**RE: B15003880**  
614 Sideling Court  
Sykesville, MD 21784

This letter is in response to building permit **B15003880**. The application describes an 18.3 ft X 17 ft sunroom addition. Upon review the building permit and site plan, the submittal did not include a copy of the floor plans of the existing house plus proposed changes. The house floor plan (basement, first and second floor) may be hand drawn. Floor plans are needed to determine if the septic system is sized properly.

# MORRIS ADDITION

### SITE PLAN

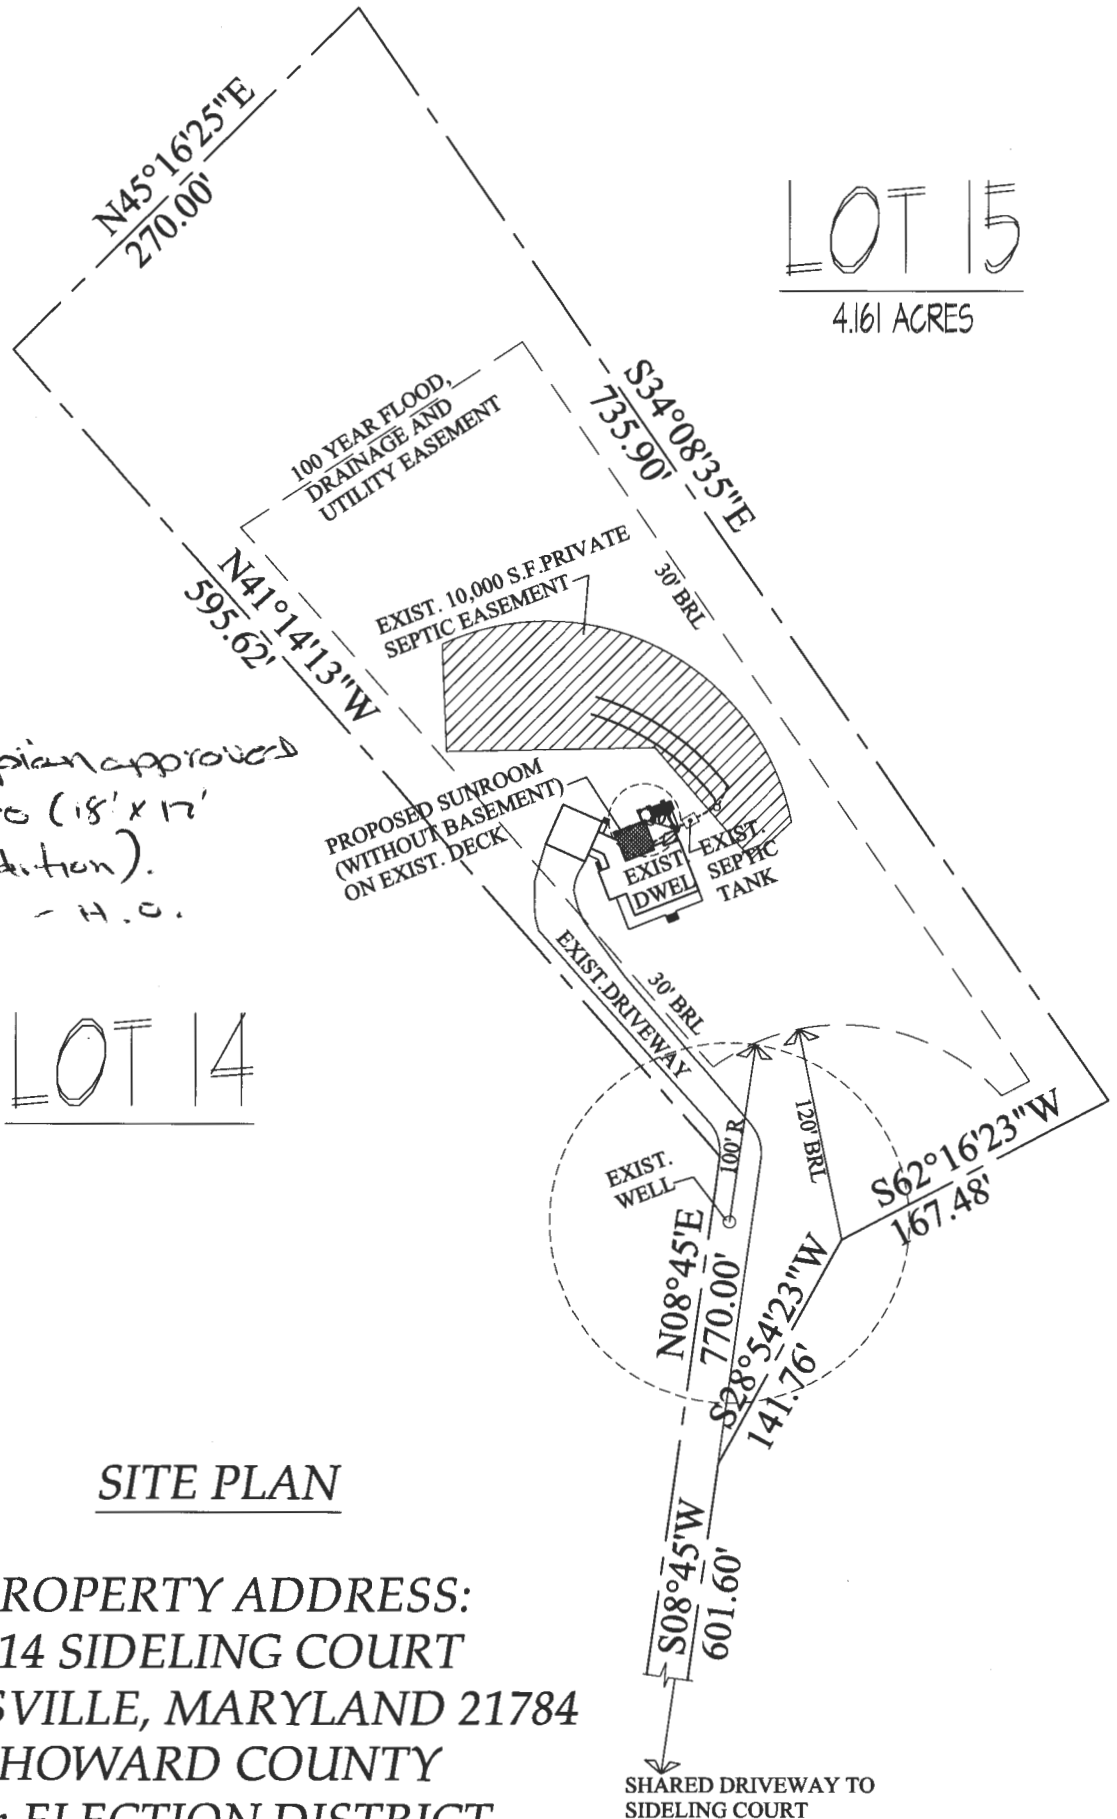
Additionally, the site plan must include any onsite well and all septic system components (tank, trench and reserve area) to ensure setback requirements are being met. Please refer to the "as-built" drawing of the septic system (attachment, pages 1 -3) for their locations and include them in the revised site plan drawing. Also, please find a copy of the setback requirements (attachment).

12/16/15 - Site plan approved  
for B15003880 (18' x 17'  
sunroom addition).  
- H.C.
